Job No: W03066.07

26 September 2006

RE: SANDON POINT PROJECT – RESPONSE TO AUTHORITY COMMENTS

Drawing: Figure 11

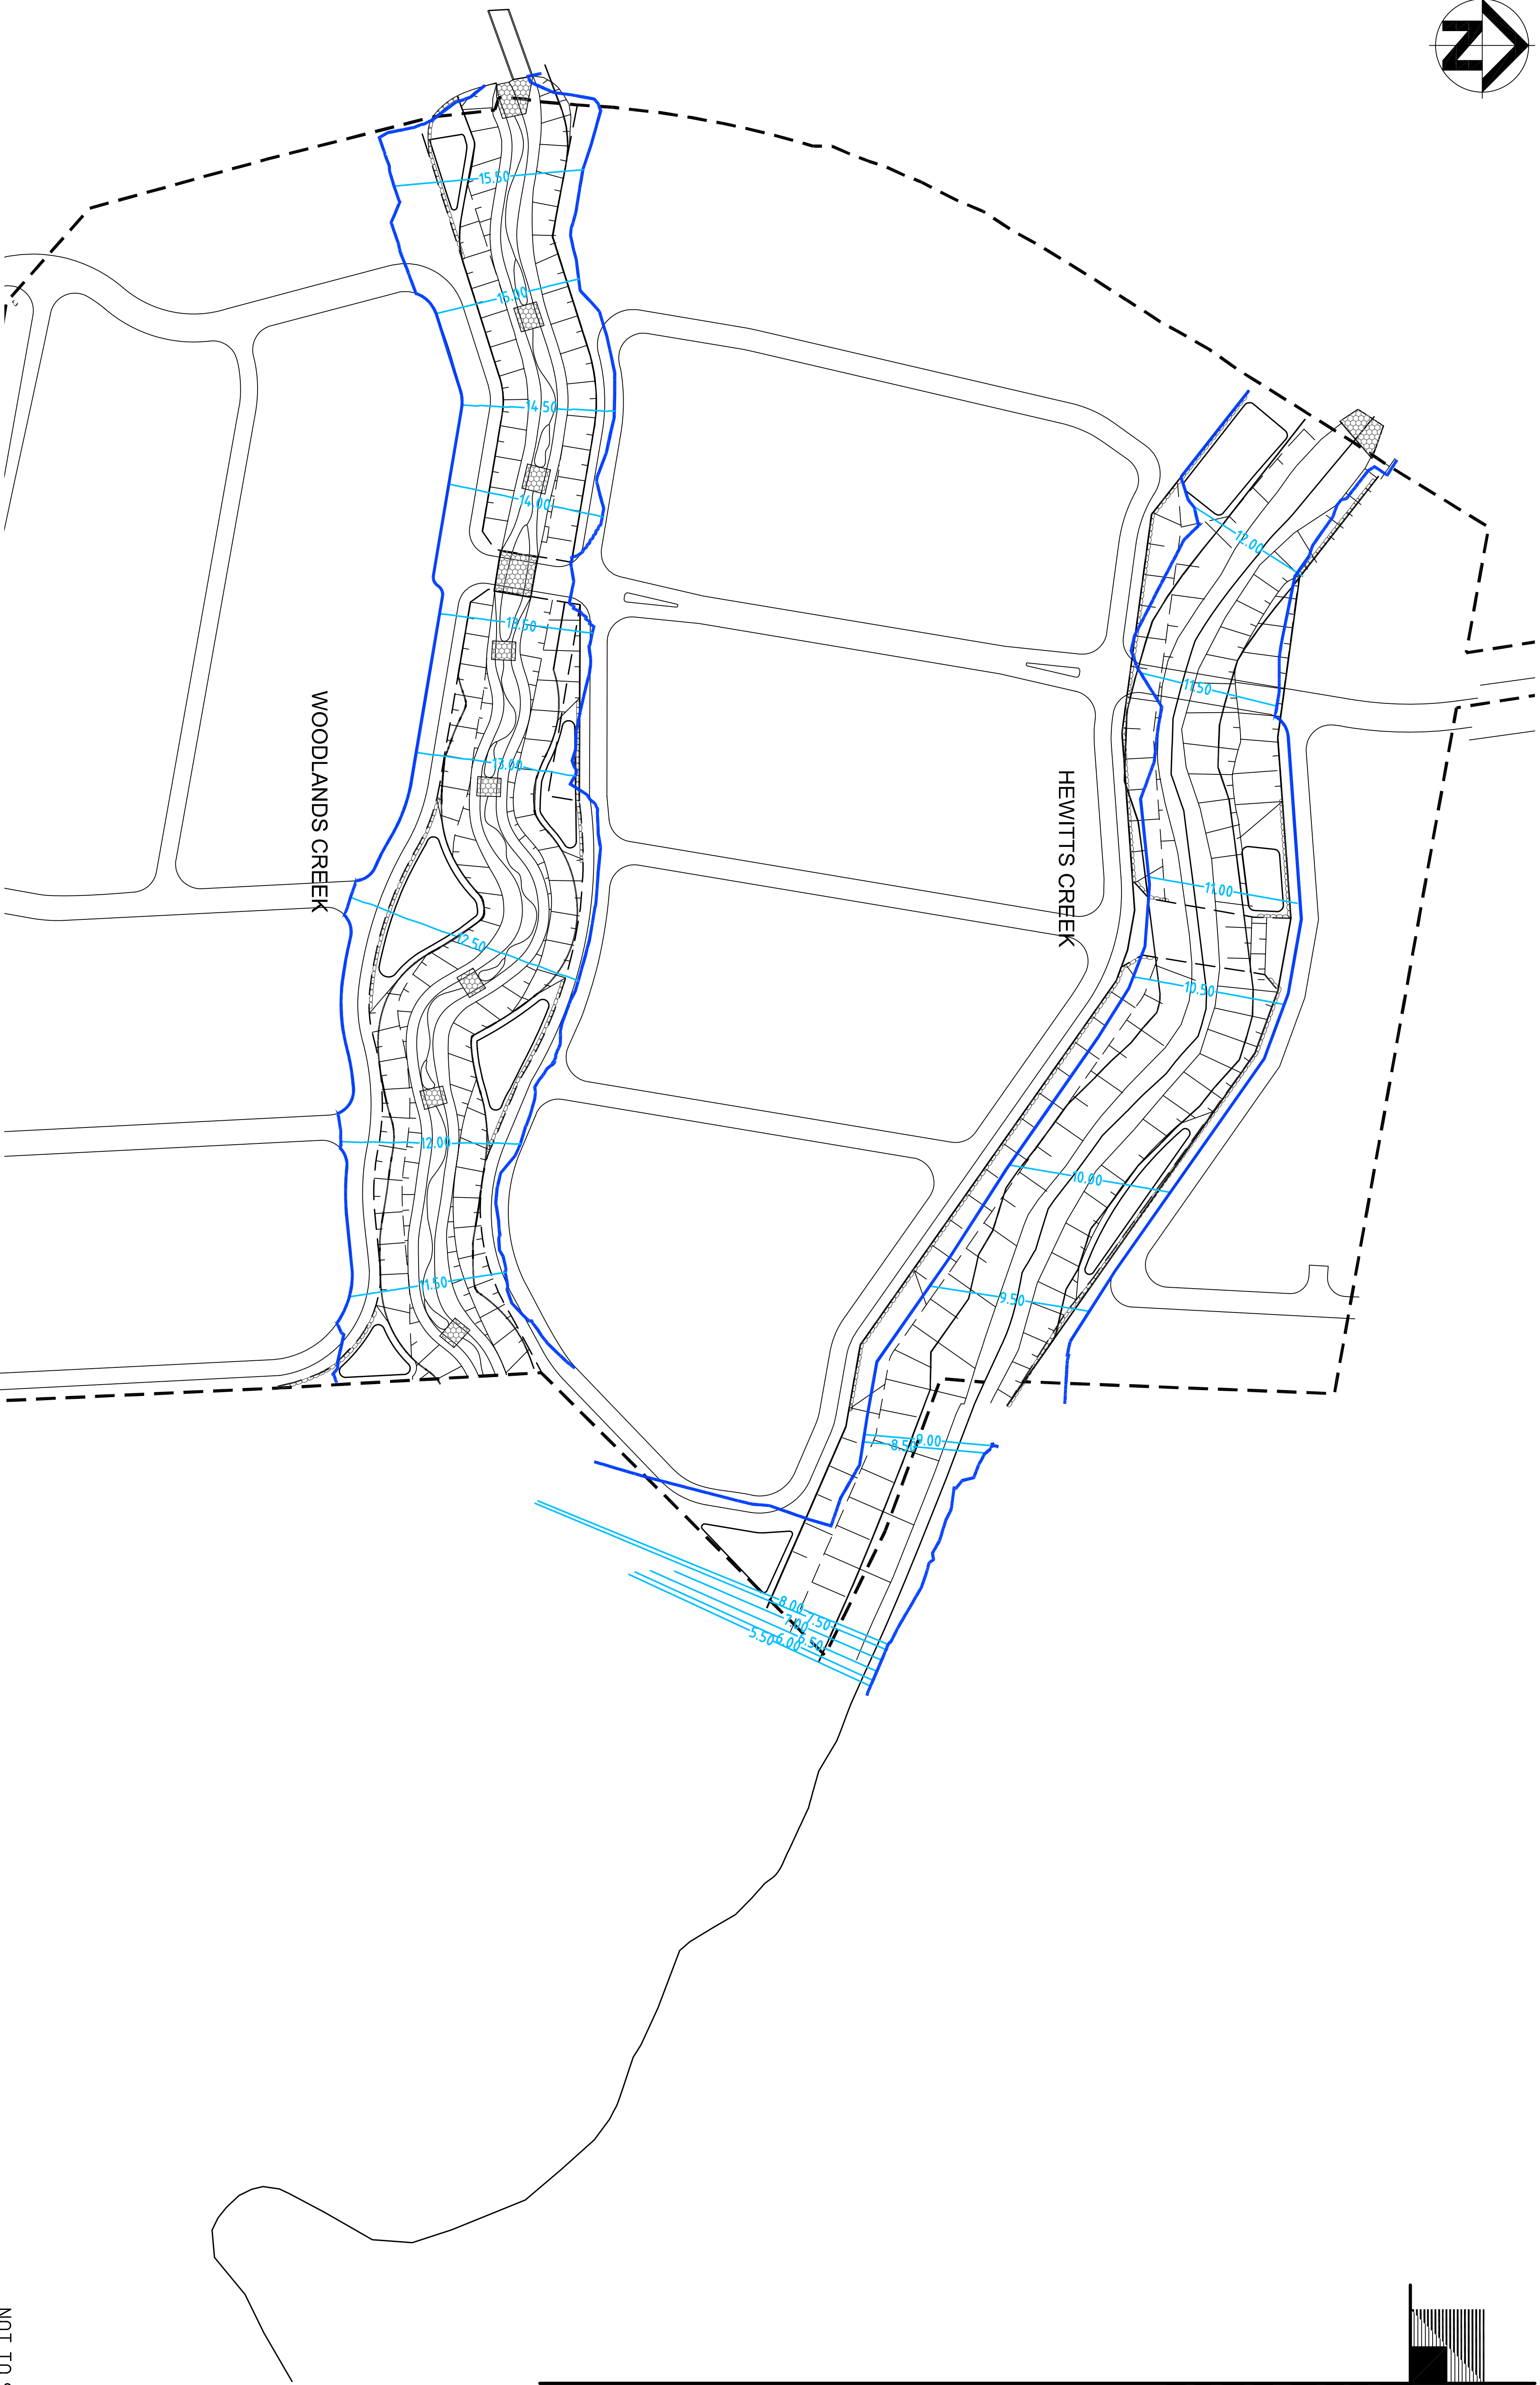
Flood maps for the post development flood extents for Hewitts and Woodlands Creek have also been attached for the 1% AEP (100 year ARI) and PMF events, Figures 11 and 12. Please note that the post development flooding extents for Tramway Creek are shown in Figure SK02 in Appendix D of our stormwater concept plan report. Maps showing the maximum proposed future flood extents adjacent to Tramway Creek are also attached.
